No. 46-C AMPLIFIER

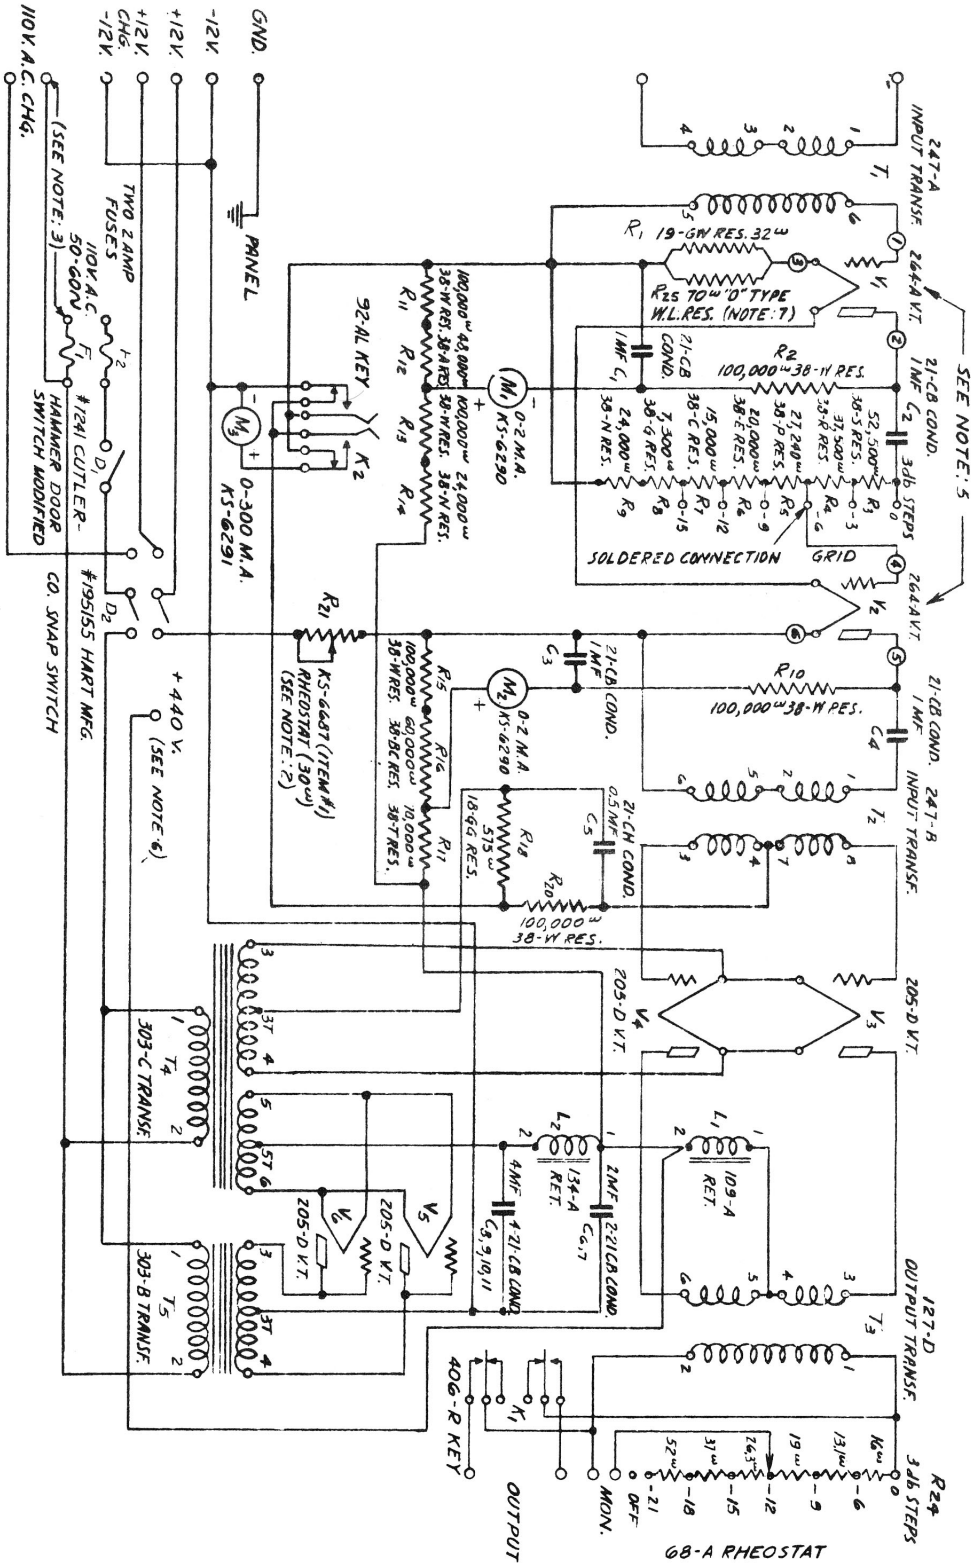
- NOTES:-
1. TERMS SHOWN THUS ① ② ③ ARE ON V.T. SOCKET TERMINAL STRIP.
  2. THE CIRCUIT SHOWN ABOVE IS FOR THE 46-C AMPLIFIER MODIFIED PER TA-139 THE CIRCUIT OF THE 46-C OR 46-F AMPLIFIER MODIFIED PER TA-140 IS IDENTICAL EXCEPT THAT THE 30Ω RHEOSTAT, R21 IS REPLACED BY THE 45-687 (ITEM #1) 45Ω RHEOSTAT.
  3. THESE TERMS ARE NICKEL PLATED, AND THE GND. SIDE OF THE 110V A.C. CIRCUIT AND OF THE CHARGER CIRCUIT RESPECTIVELY, MUST BE CONNECTED TO THEM.
  4. FOR REPLACING THE 21-CB CONDENSERS, C3 TO C5, IN THE FIELD ORDER D-92583 CONDENSERS, WHICH HAVE A HIGHER BREAKDOWN. THIS REPLACEMENT IS NOW BEING MADE ON 46 TYPE AMPLIFIERS BEFORE SHIPMENT FROM THE WAREHOUSE.
  5. 264-A VACUUM TUBES REPLACE 239-A.
  6. +440 V. TERMINAL ADDED.
  7. R5, 10Ω TYPE 07WL. RESISTANCE ADDED.
